APPENDIX IV
DETAILS OF CASK RESPONSE TO FIRE ACCIDENTS

APPENDIX IV

DETAILS OF CASK RESPONSE TO FIRE ACCIDENTS

Figure IV-1. CAFE three-dimensional domain: (a) CAFE regulatory fire, (b) cask on ground and at the center of the pool, (c) cask on the ground and 3m (10ft) from the edge of the pool, (d) cask on the ground and 18.3m (60ft) from the edge of the pool.

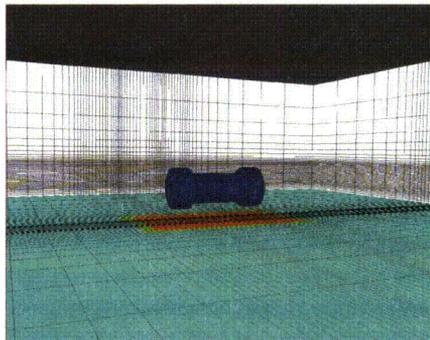
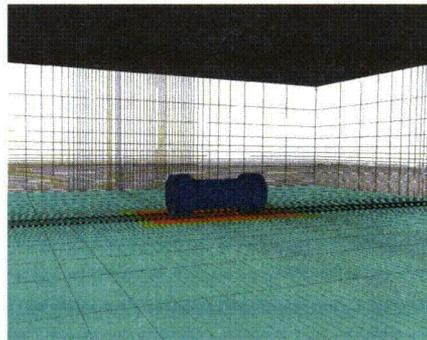
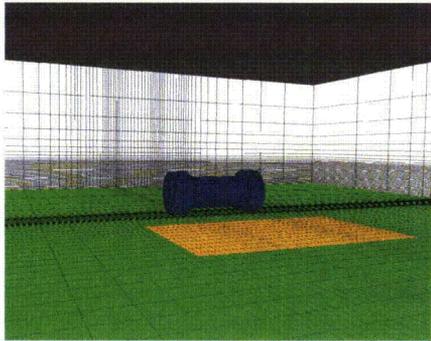
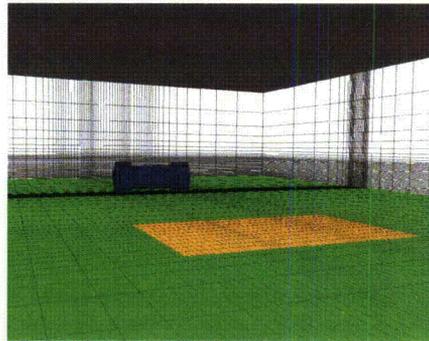
Comment [csb8]: These figures are a little fuzzy, may be fine when printed in a full size document.

Figure IV-2. Rail-Steel cask: (a) assembly of MPC and overpack, and (b) cask with limiters.

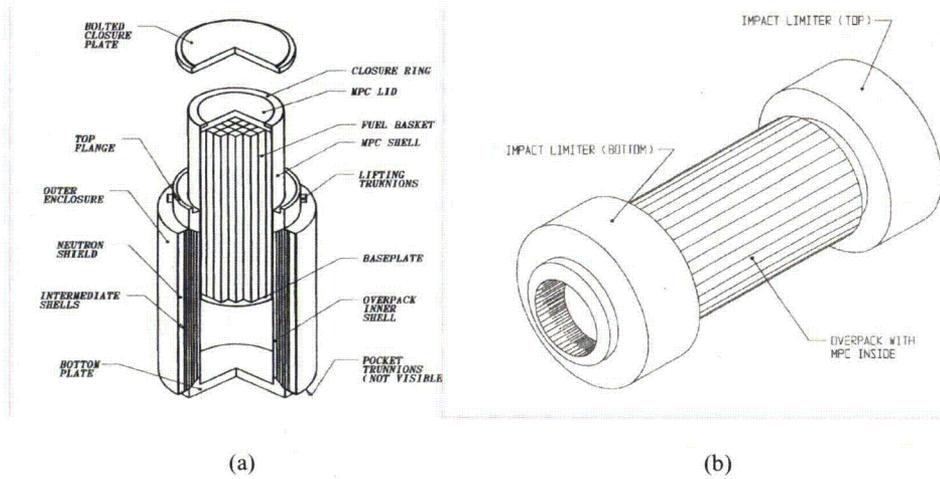
Comment [csb10]: Be sure to reference all the figures that come from the HOLTEC SAR

Figure IV-8. Rail-Steel finite element mesh.

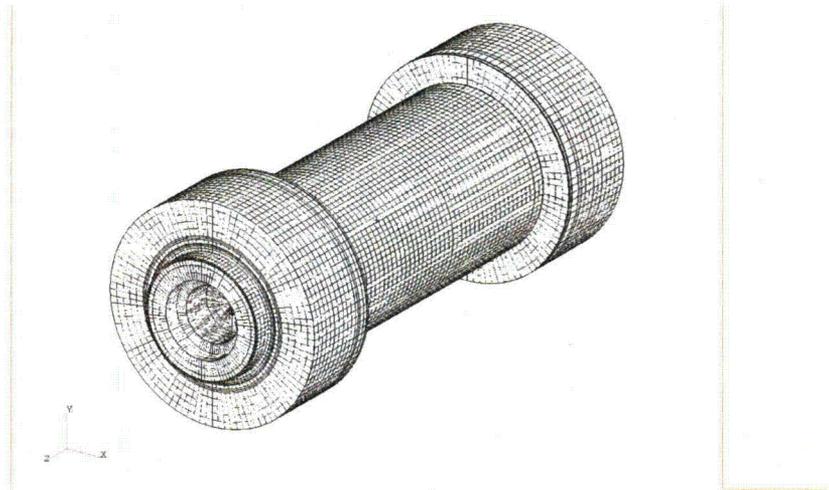
Comment [csb21]: I would list this and any other sensitivity studies done for this report in a table for easier consumption.

Comment [csb22]: Could you provide a cross section of this package model?

Figure IV-25. Side view (looking from the north) of calorimeter and test setup. Note: the calorimeter is centered with the pool. This drawing is not to scale.

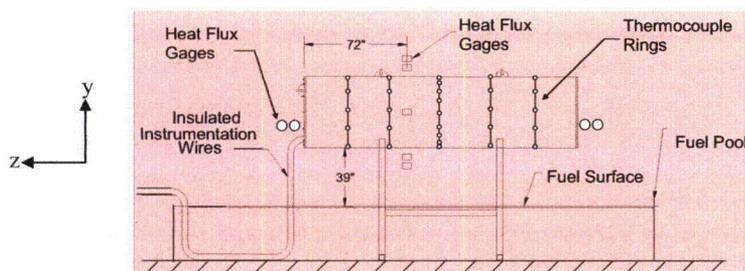
Comment [csb32]: May not be clear on what this is.

Comment [csb33]: This figure did not come out when I printed the document.
